Access Compliance Report Public Rights-of-Way (Curb Ramps)

Main Street: FOLLATE_WAY		Cross Street: FALLOW_LN		Location:	NE
ADA ID: RPRK211028124611	Ramp Type: Type 4 - Parallel	Initial Pass/Fail: Fail	Overall Compliance: No	Severity Score:	16
Codes/Mitigation Info/Possible Solution			Field Measurements/Component Compliance

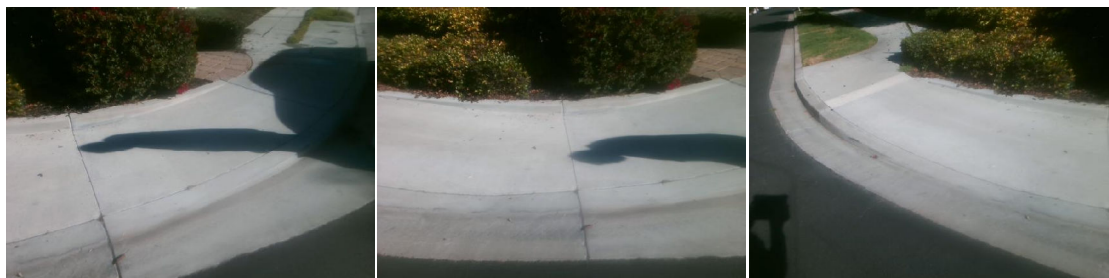
Compliance	Description	Data	Compliance	Description	Data
N/A	Ramp Length LT (in)	123	N/A	Ramp Length RT (in)	139
Yes	Ramp Width LT (in)	52	Yes	Ramp Width RT (in)	52
No	Ramp Run Slope LT (%)	10	Yes	Ramp Run Slope RT (%)	2.3
No	Ramp Cross Slope LT (%)	2.6	Yes	Ramp Cross Slope RT (%)	0.7
N/A	Landing Present	N/A	N/A	DWS Provided	N/A
N/A	Landing Length (in)	N/A	N/A	DWS Contrast	N/A
N/A	Landing Width (in)	N/A	N/A	DWS Length (in)	N/A
N/A	Landing Run Slope (%)	N/A	N/A	DWS Full Width	N/A
N/A	Landing Cross Slope (%)	N/A		DWS Offset Type	N/A
N/A	Landing Movement Obstructed?	N/A	N/A	DWS Offset Left (in)	N/A
	Landing Movement Type	N/A	N/A	DWS Offset Right (in)	N/A
N/A	Landing Shared	N/A			
N/A	Clear Space	Yes			
N/A	Clear Space To Crosswalk (in)	N/A			
N/A	Marked Crosswalk 1	No	N/A	Marked Crosswalk 2	No
	Crossing 1 Direction	W		Crossing 2 Direction	S
	Marked Crosswalk 1 Width (in)	N/A		Marked Crosswalk 2 Width (in)	N/A

Remove & Replace Curb Ramp With Two New Directional Ramps or Equivalent.
